## BEACHES LINK EIS OBJECTION 1<sup>st</sup> March 2021

Neil Christiansen – 82 Kirkwood Street, Seaforth, NSW

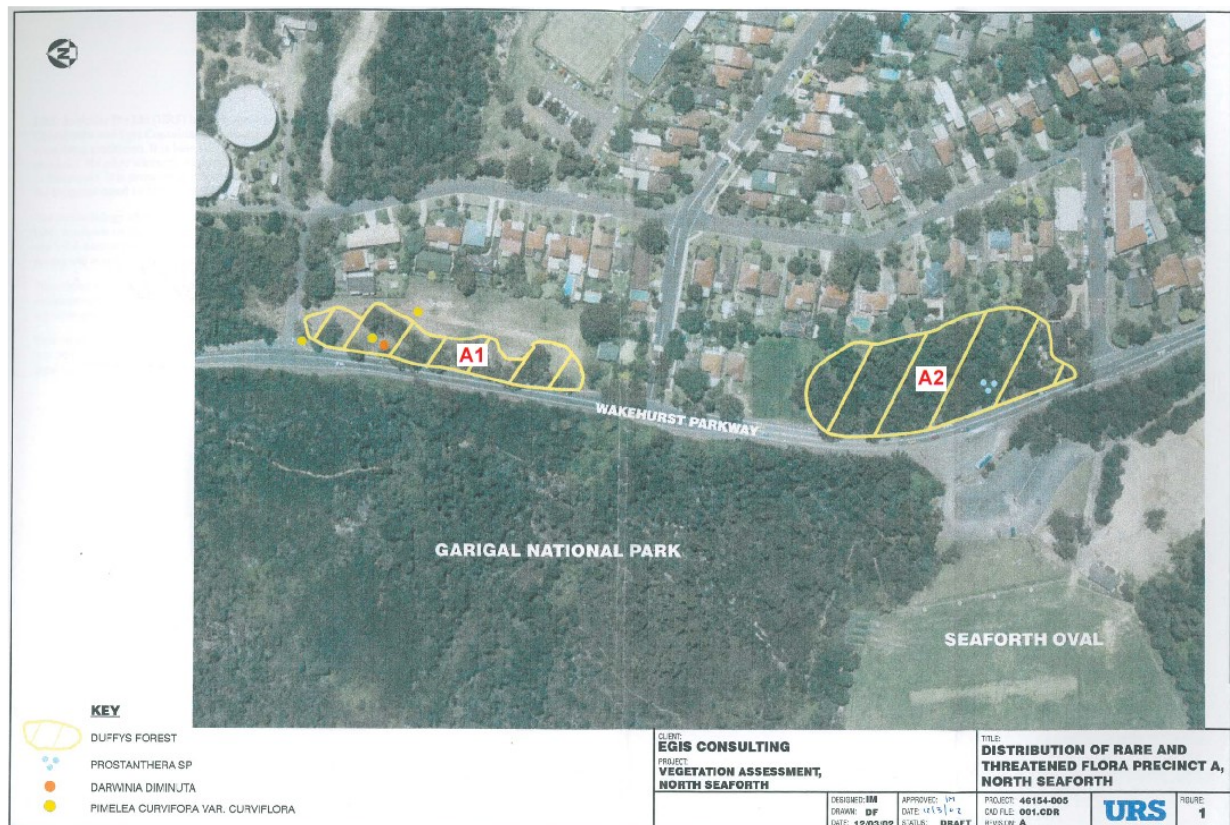
There are inadequate provisions to prevent the loss of environmentally sensitive and significant vegetation in the parcel of land between the northern end of Kirkwood Street and Wakehurst Parkway which is proposed to be used as a Construction support site BL12. There are a number of significant land mark trees and environmentally sensitive vegetation in this proposed worksite area. A significant tree at the rear of No 76 Kirkwood Street particularly warrants retention as it one of the largest and tallest trees in the area and we understand it is used by boat operators as a boat

sighting. The site has also previously been identified in 2003 as possessing threatened and endangered flora as outlined below.

The loss of this environmentally sensitive and significant vegetation is not necessary in its entirety, simply for the purposes of establishing a Construction Support site for parking and offices and laydown areas. The retention of the more significant vegetated areas should be possible, whilst enabling these activities albeit in a reduced footprint.

We request that suitable conditions be imposed to enable the retention of significant and environmentally sensitive vegetation to be retained on this site and that the whole site not be cleared indiscriminately without a genuine attempt being made to retain significant and environmentally sensitive vegetation.
